RE: H59-6060-MJ: Horry Georgetown Grand Strand Culinary Building Construction

ADDENDUM #2

OSE PROJECT NUMBER: H59-6060-MJ
DATE: OCTOBER 28, 2014
DRAWN BY: KJMM
CHECKED BY: MGWPLUMBING
DOMESTIC
WATER & GAS
ENLARGED
VIEWS

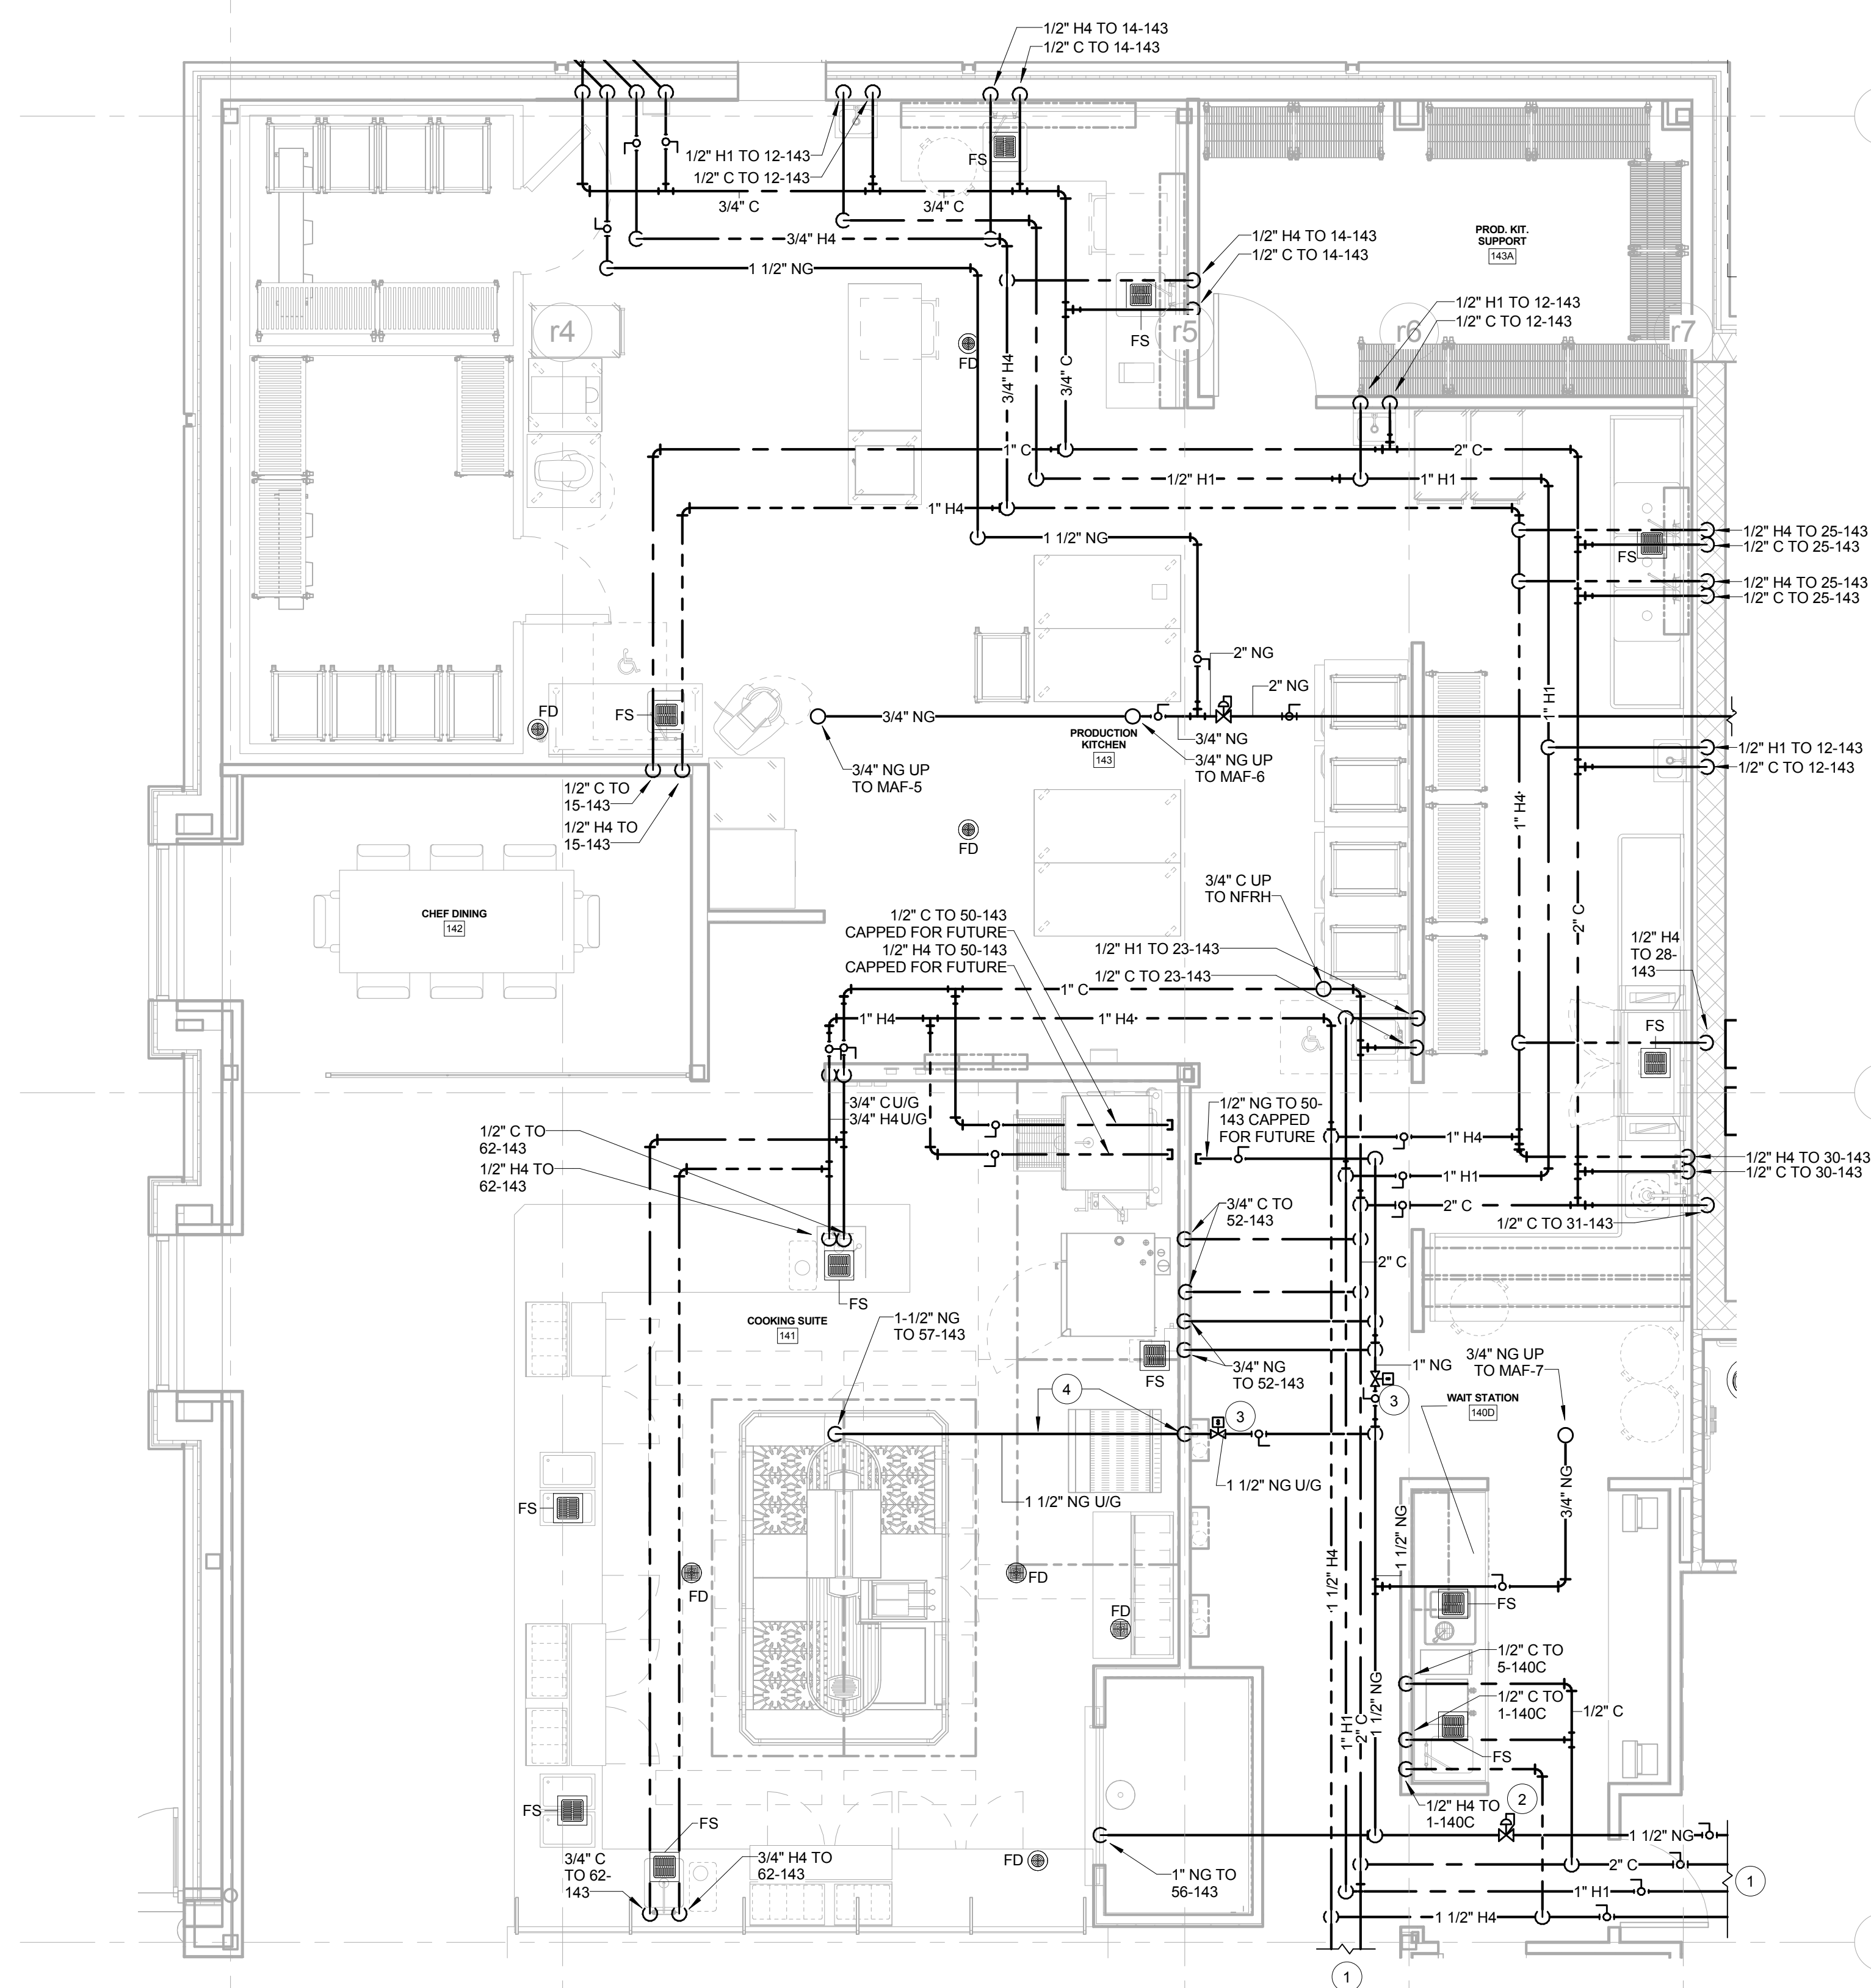
Sheet P402 – Plumbing Domestic Water & Gas Enlarged Views **Reissued**. Detail 3/P-402 has been added. Revised sheet in Adobe.pdf format attached to this Addendum.

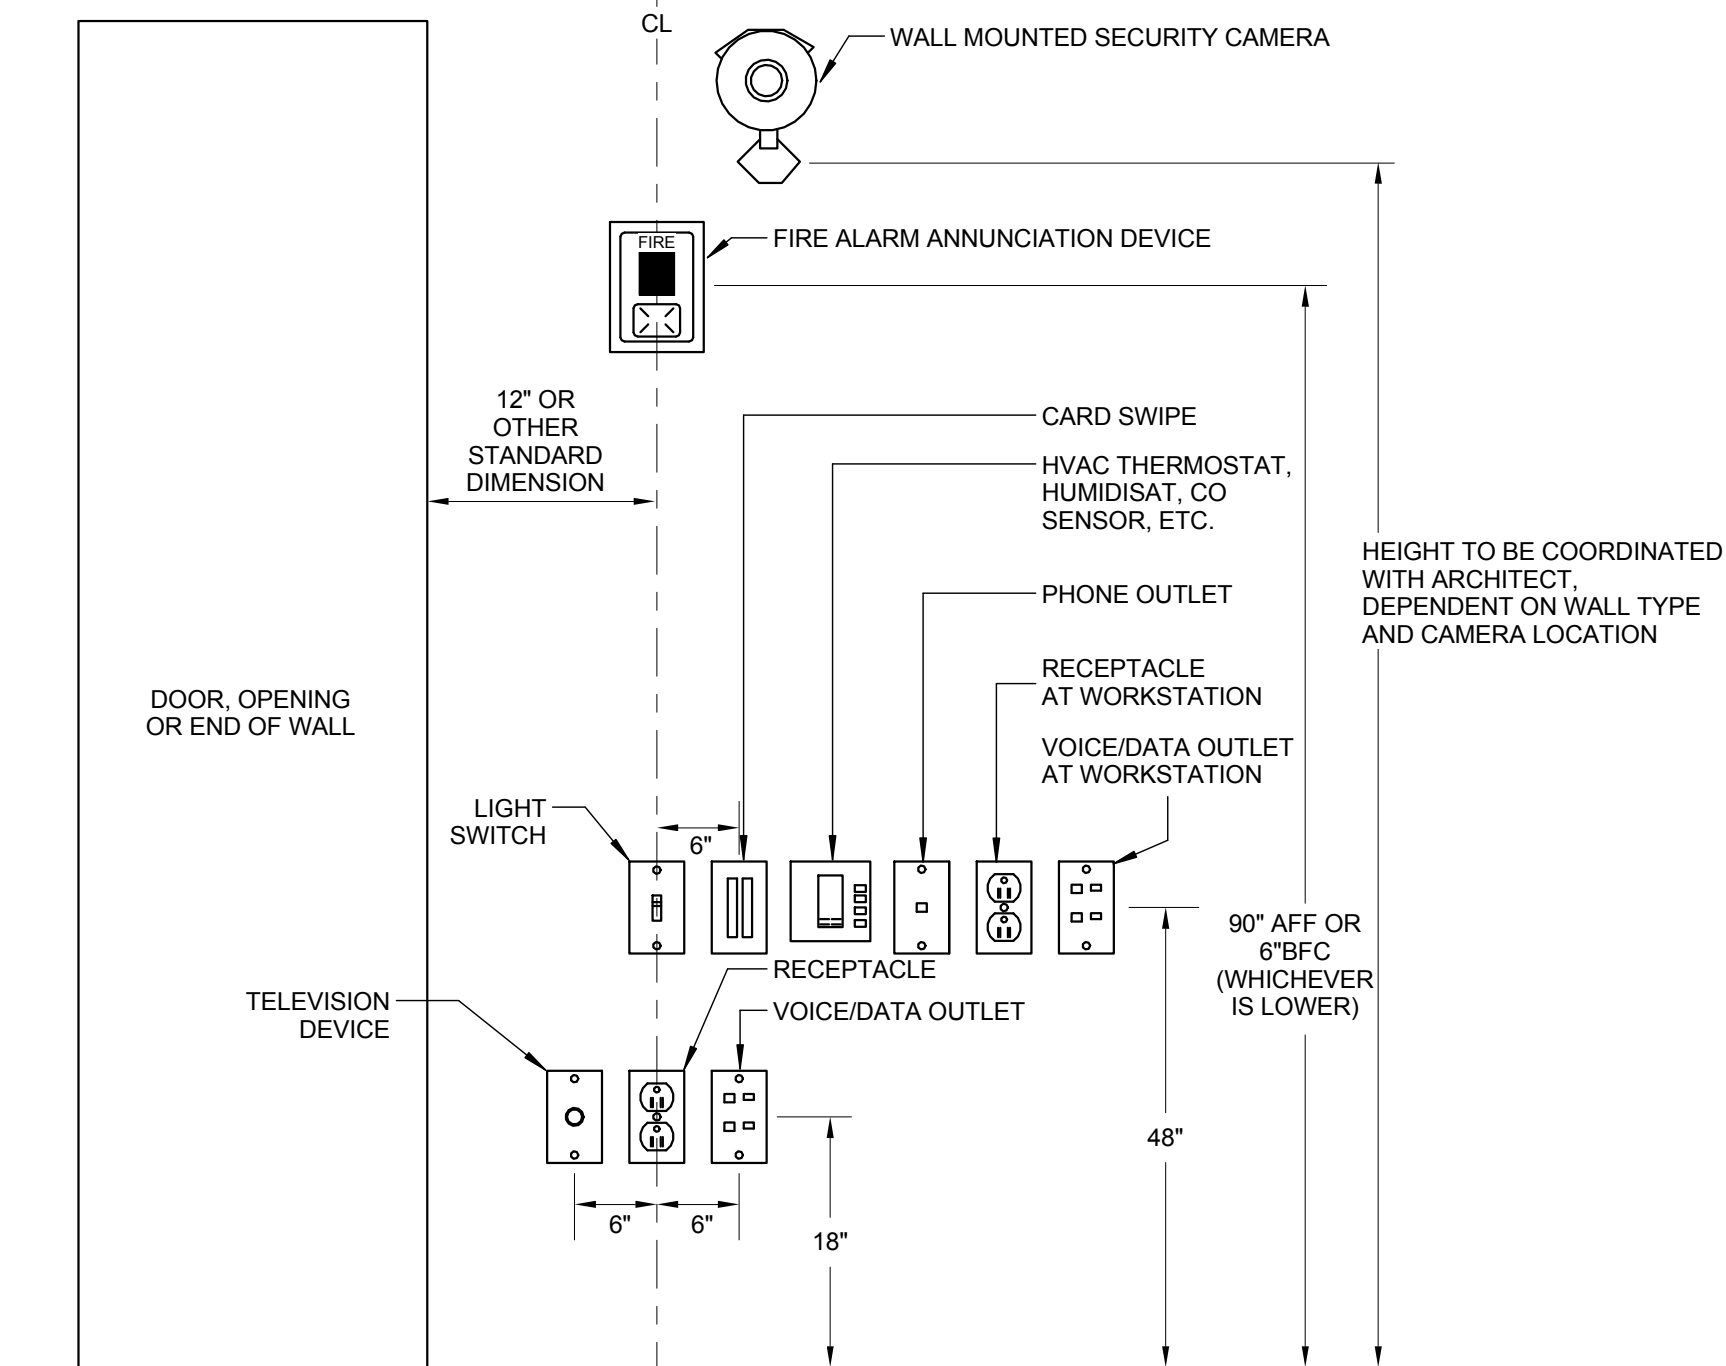
Sheet E001 – Electrical Legend & Notes **Reissued**. General note added regarding removal of IT/AV/Security cabling from this contract. (This is further clarified in Project Manual revisions noted in Project Manual section of this addendum.) Revised sheet in Adobe.pdf format attached to this Addendum.
